RESPONSE TO REQUEST FOR ADDITIONAL INFORMATION

APR1400 Design Certification

RAI No.: 390-8479
SRP Section: 12.02 – Radiation Sources
Application Section: 12.02
Date of RAI Issue: 02/01/2016

Question No. 12.02-26

Figure 1. Location of CR Emergency ACUs above the MCR

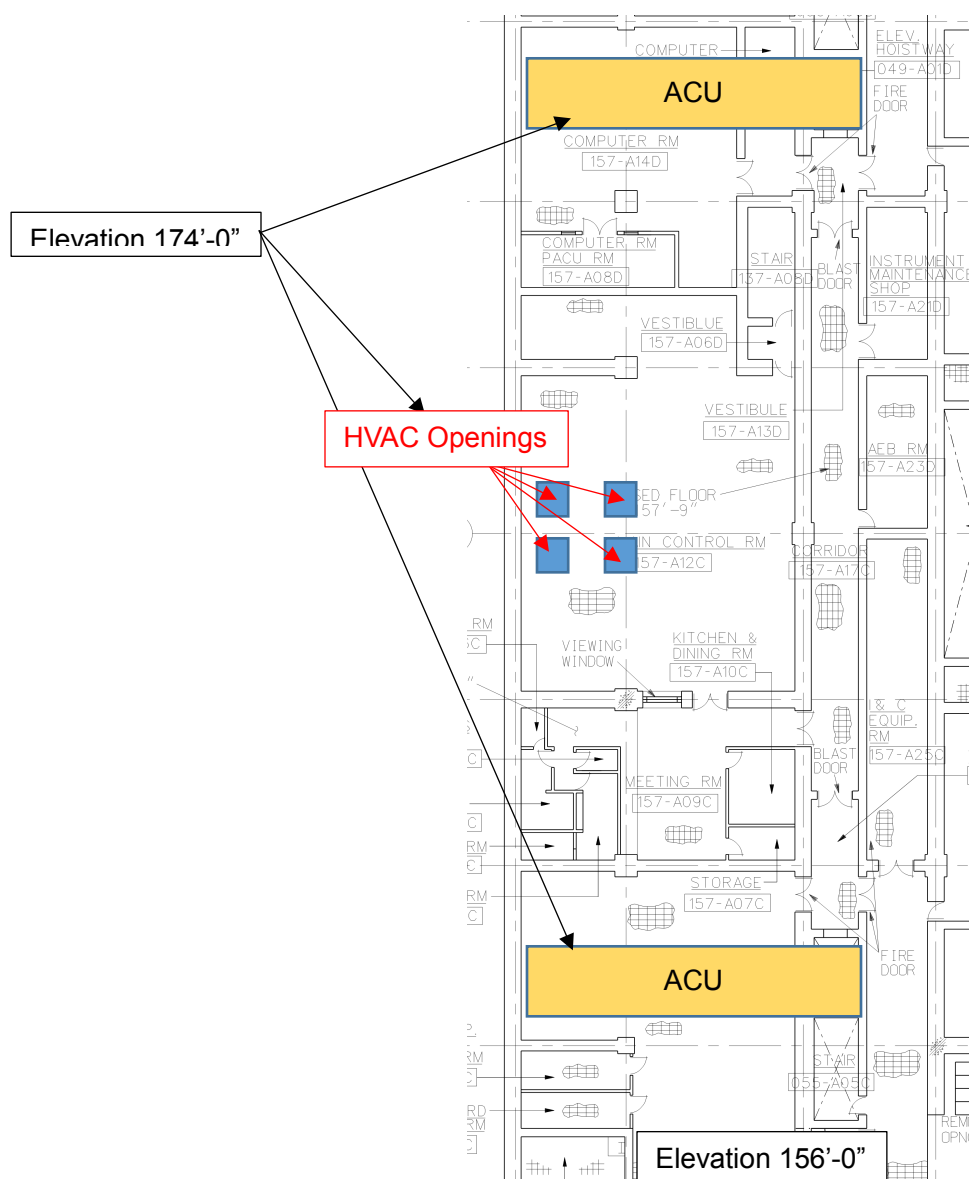
3. In the response, the applicant provides information indicating that containment penetrations will not be a significant dose contribution to CRE dose. Please specify if the design is such that it prevents a direct radiation streaming path or near direct radiation streaming path from the emergency filters (located above the main control room.) into the CRE through the ventilation ducting openings or other penetrations into the CRE.

- The two control room emergency air cleaning units, at elevation 174'-0", are not located directly above the main control room (MCR) at elevation 156'-0"; one is located above the computer room (plant north side of the MCR), and the other above the TSC room on the south side of the MCR. Their locations are indicated in the attached sketch (Figure 1) for illustration purposes. Based on these locations, the air supply and exhaust duct penetrations are designed to be located away from the CR Emergency ACU to prevent direct, or near direct, radiation streaming pathways.
